Addendum to the Draft Final Proposal

Bid Cost Recovery Mitigation Measures

April 27, 2012

Bid Cost Recovery Measures

Figure 1: Current payment for residual imbalance energy

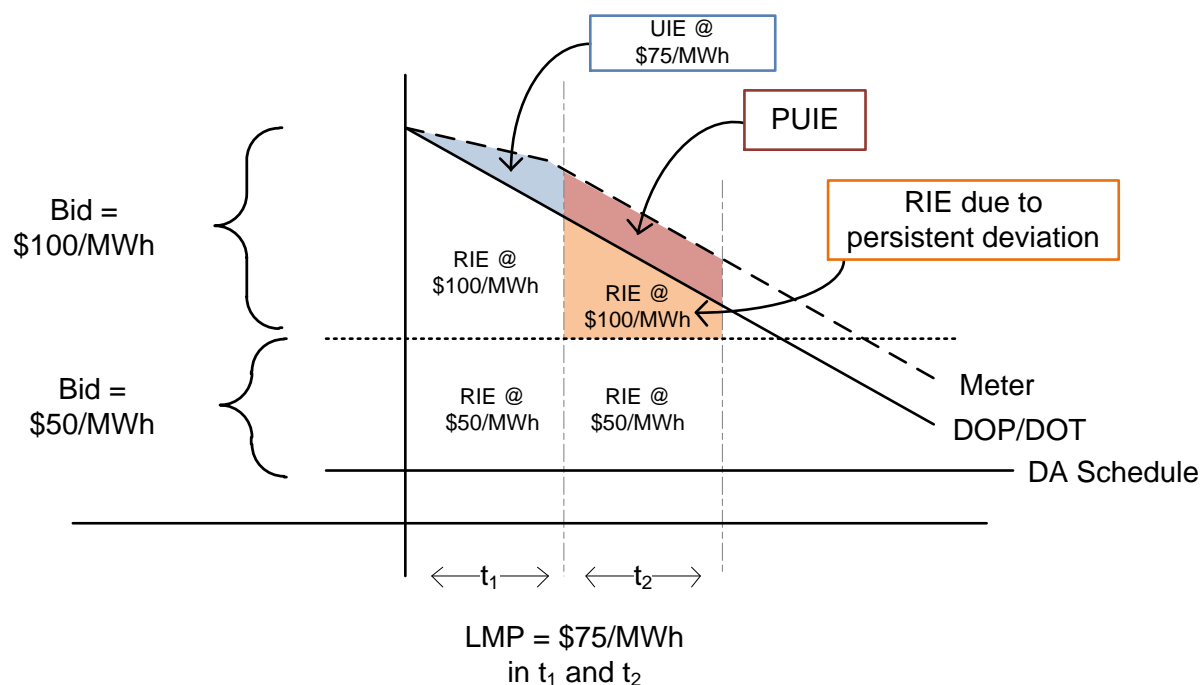
Analysis of instances of residual imbalance energy has shed light on a potential problem with the payment for that energy. In particular, uninstructed deviations from ISO dispatch that are categorized as residual imbalance energy are paid at the bid price for the resource (if there is one in the previous or next hour) rather than at the LMP for the current interval. The ISO proposes that, in the case that the persistent deviation pattern is detected, that residual imbalance energy be paid the LMP.

This is illustrated in the diagram below. A few items to note:

In interval 1 (t_1), energy above the day-ahead schedule and below the dotted line is residual imbalance energy, and is settled at the price of the bid in the previous interval (\$50/MWh). Likewise, energy in the range where the resource's bid curve from the prior hour is for \$100/MWh, between is settled at that \$100/MWh so long as that energy is less than the ISO dispatch (DOT). Above the DOT, the energy is deemed "uninstructed imbalance energy" and is settled at the LMP.

In interval 2 (t_2), note that the same pattern applies for the areas below the DOT line. However, above the bid price, and below the DOT/DOP is residual imbalance energy is settled at the bid price of \$100/MWh. This is represented as the orange area in the diagram above. In this case, the fact that there is RIE is due to the persistent downward deviation.

The ISO proposes to close this gap in the current settlement of RIE by settling RIE at the LMP for the contemporaneous interval. In summary,

- If there is no PUIE, then RIE settles as today.
- If there is PUIE (as determined by the evaluation of Measures A and B, detailed in the draft final proposal) then
 - If persistent upward deviations trigger the PUIE check, then positive RIE will settle at the LMP;
 - If persistent downward deviations trigger the PUIE, then negative RIE will settle at the LMP.
